ADDENDUM 1

DATE: 01/30/18
PROJECT: UCT Expansion Interior Buildout
RFP NO: RFP 744-R1805 – UCT Expansion Interior Buildout
OWNER: The University of Texas Health Science Center at Houston
TO: Prospective Proposers

C1 STAIR ELEVATION
SCALE: 3/8" = 1'-0"

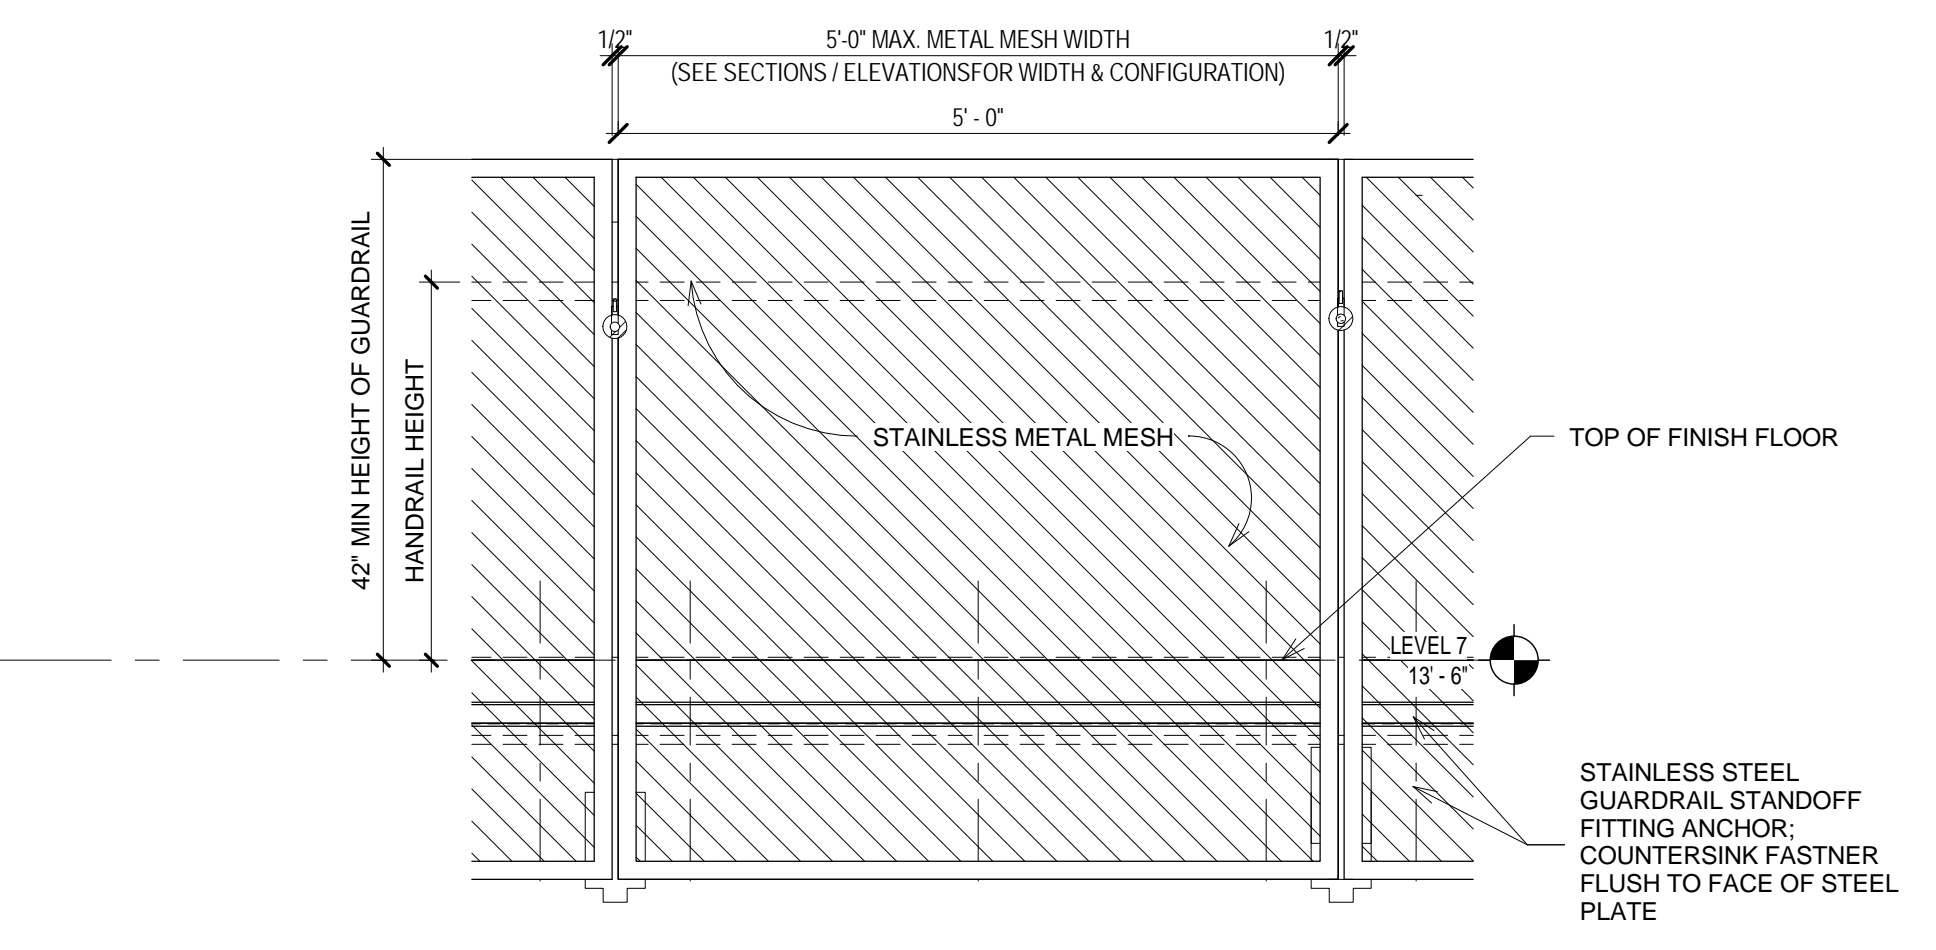
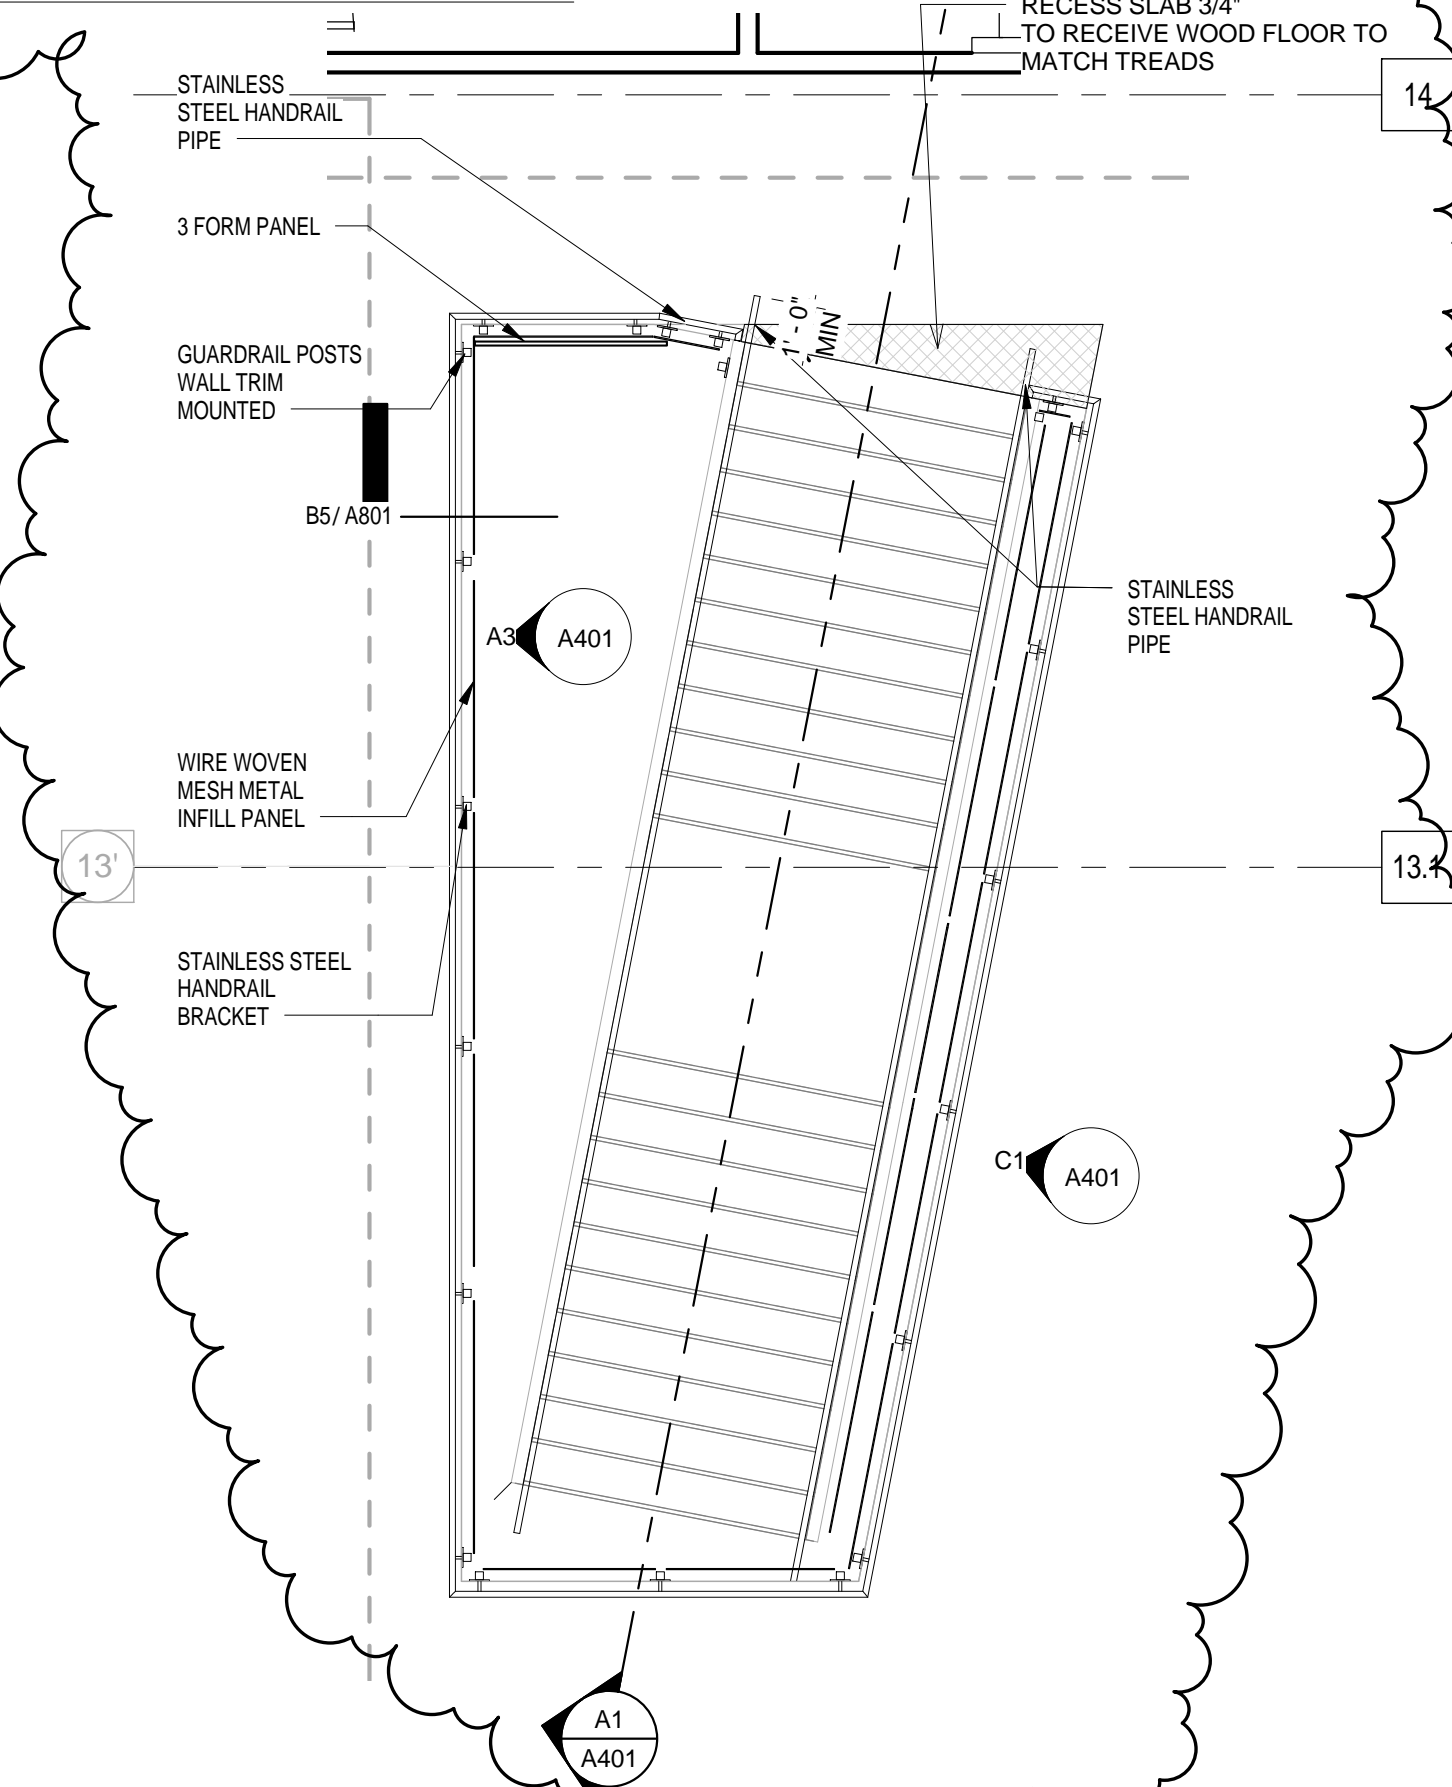
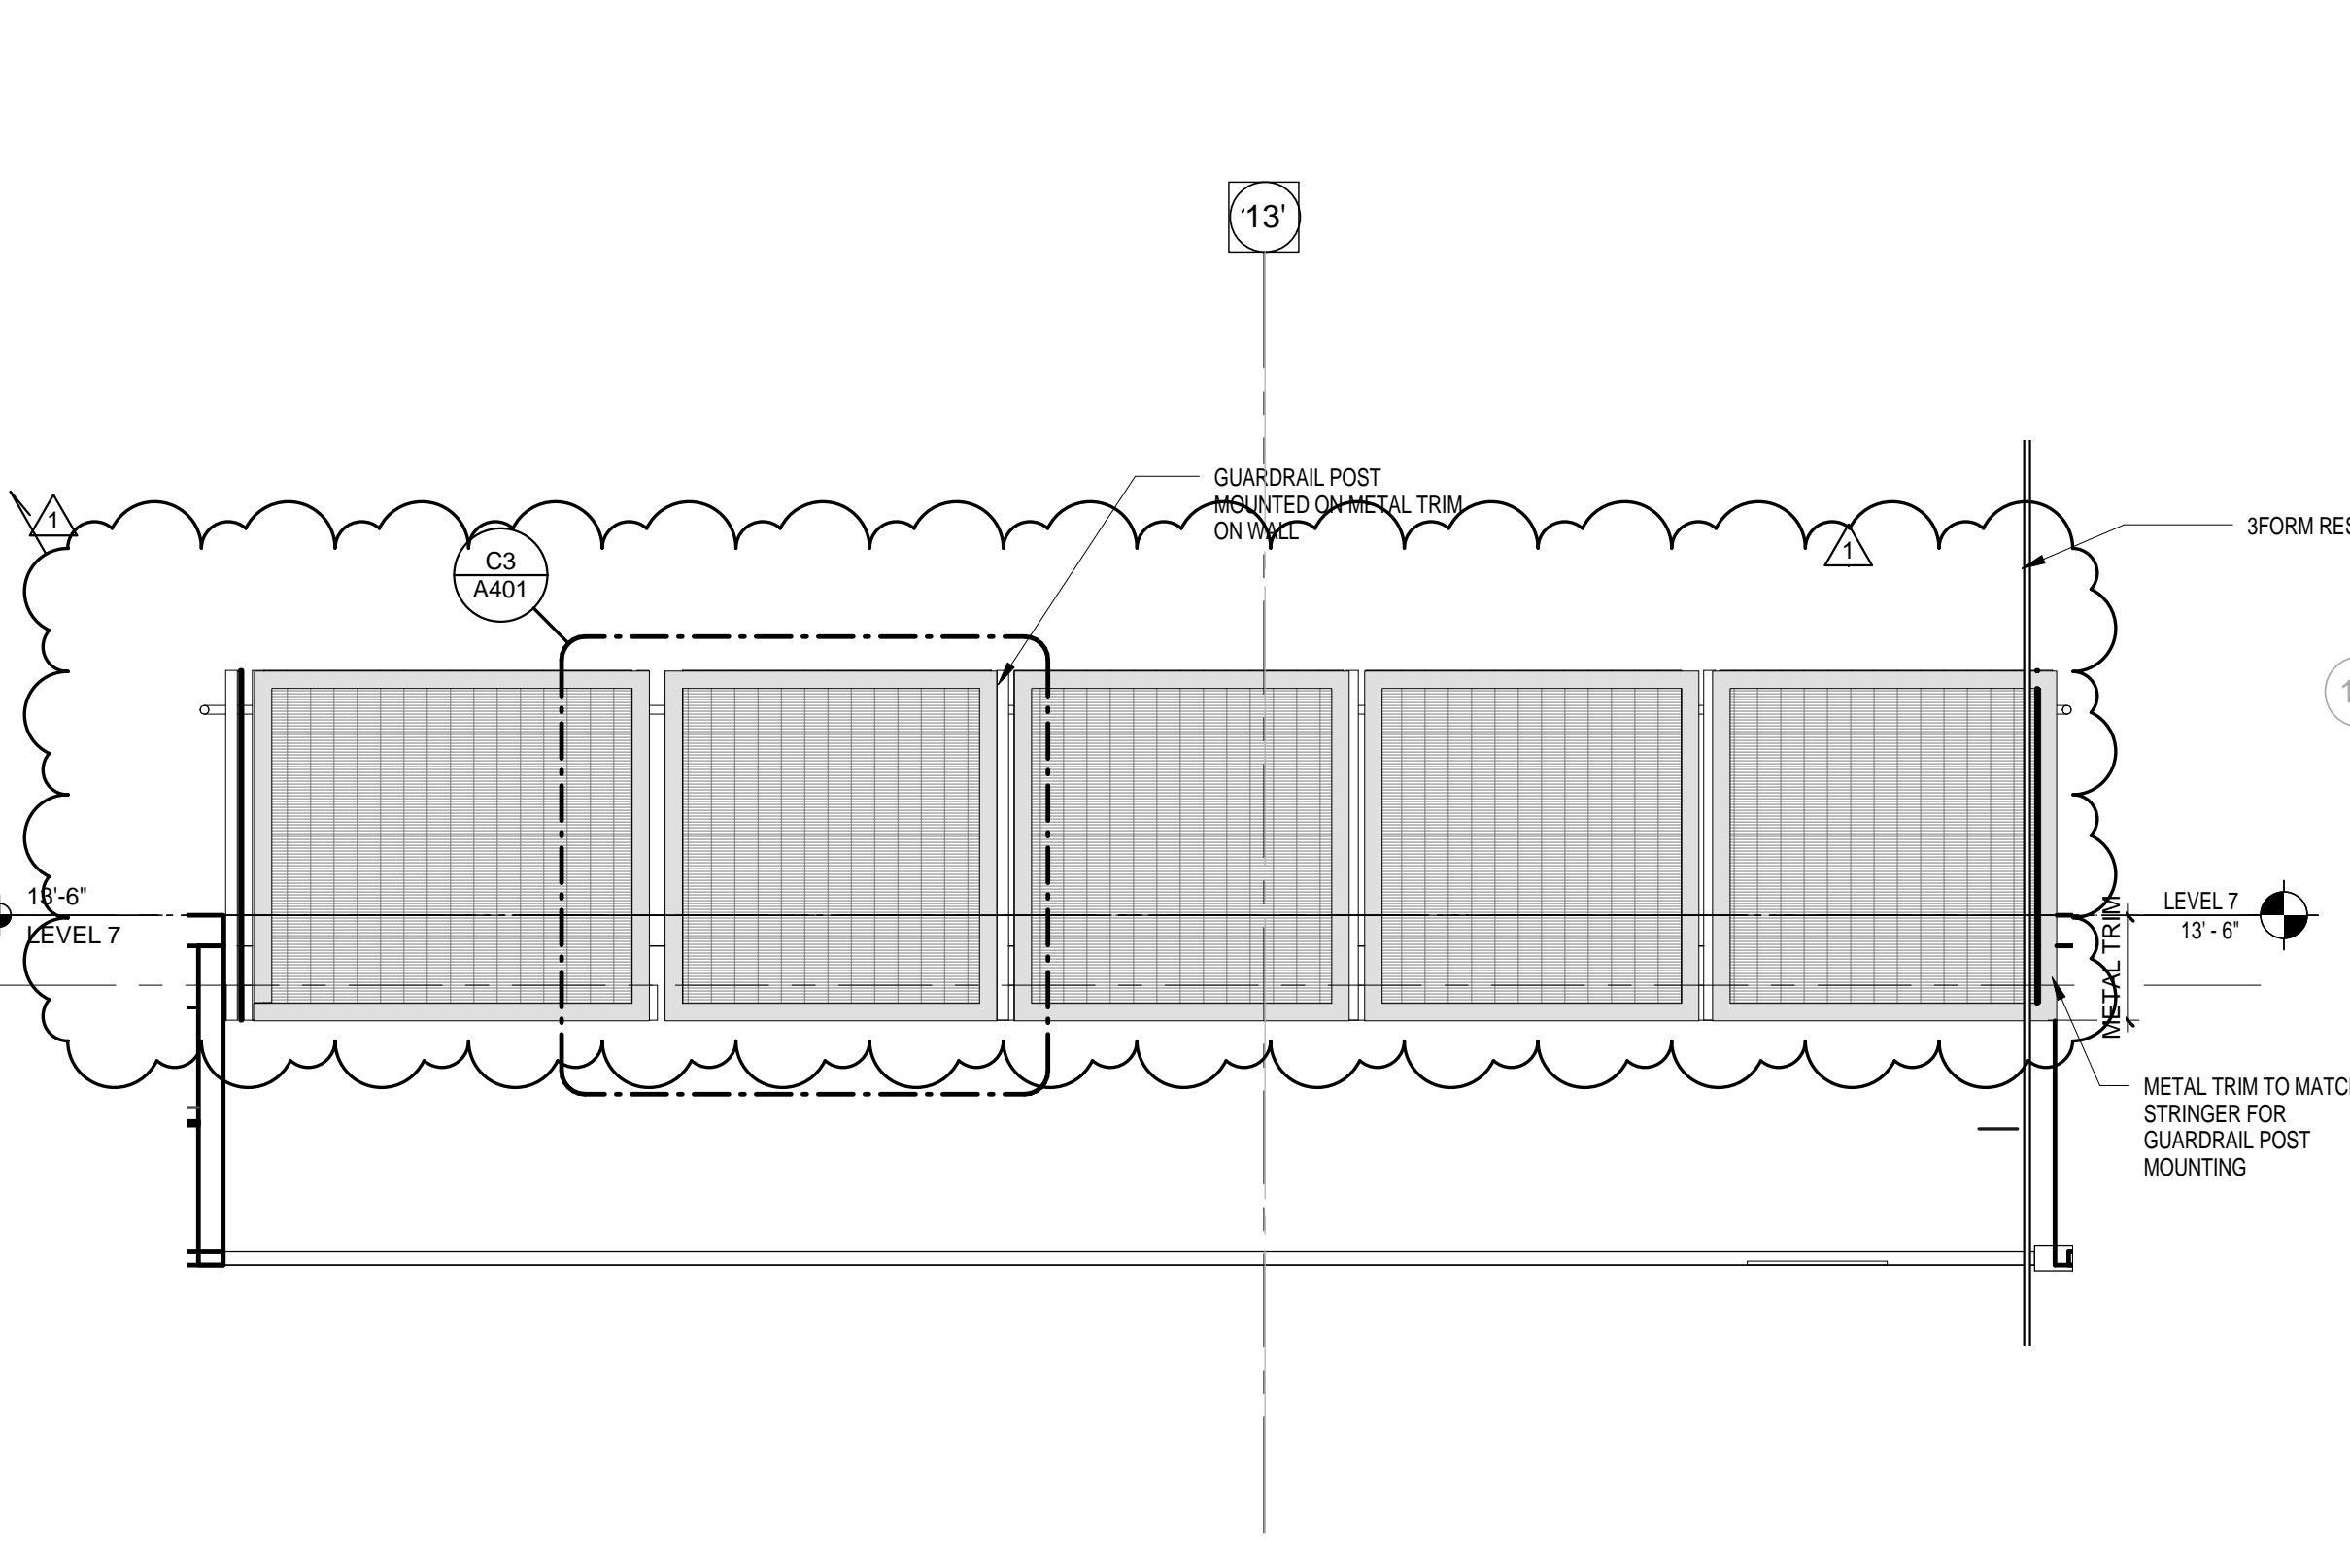
31. Sheet A401 – Please provide the following clarifications:

a. Detail C1 – Please provide detail for Guard Rail Stainless Steel “Flat and Angle Frame”

b. Detail C3 – Please clarify how mesh support tubes are mounted to the stringers.

c. Detail C3 – Detail indicates stainless steel fascia. Please clarify if this fascia is existing or part of this project installation. If part of this project, please provide details and location of stainless steel fascia.

d. Please clarify handrail. Details A1 & C1 indicate a single line rail, while A3 & D1 indicate a 4-line rail.

Provided

Vertical Support tubes to be mounted on stair stringer see drawing for notes

Stringer part of the core and shell project. No Steel Fascia to be used.

Single line handrail is to be provided

All details to be provided in Addendum 1 documents

32. Sheet A401 – Detail C5 indicates wood flooring to match existing stair treads. Please provide wood floor material selection and specifications.

a. Is the extent of the wood flooring to be the hatched square shown in this detail only?

Flooring and treads will be added into the interior Buildout set in an Addendum.
1 1/2" WALNUT WOOD TREAD

E2 RECEPTION ACCENT WALL
SCALE: 1 1/2" = 1'-0"

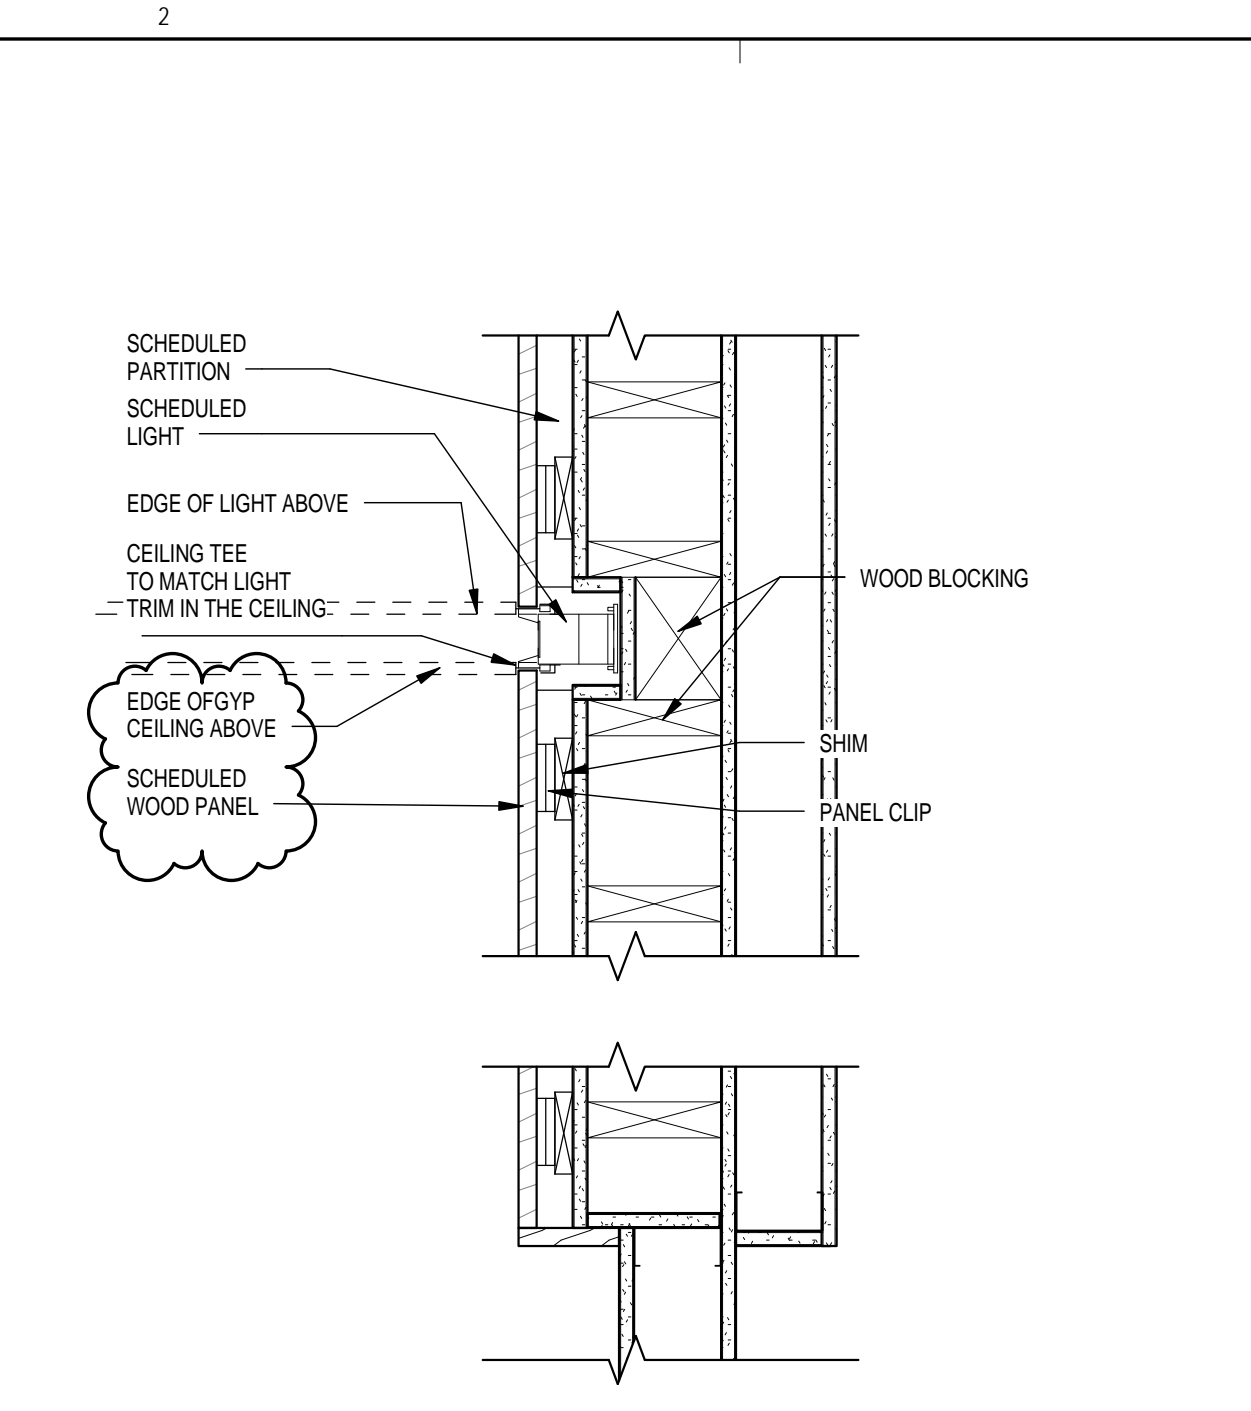
39. Sheet A801 – Detail E2 indicates wood panels at the Reception Accent Wall, however Sheet A702/A3 elevation indicates paint. Please clarify the wall finish in this location.

Accent wall is painted gyp, not wood panel. Ceiling is painted gyp as well
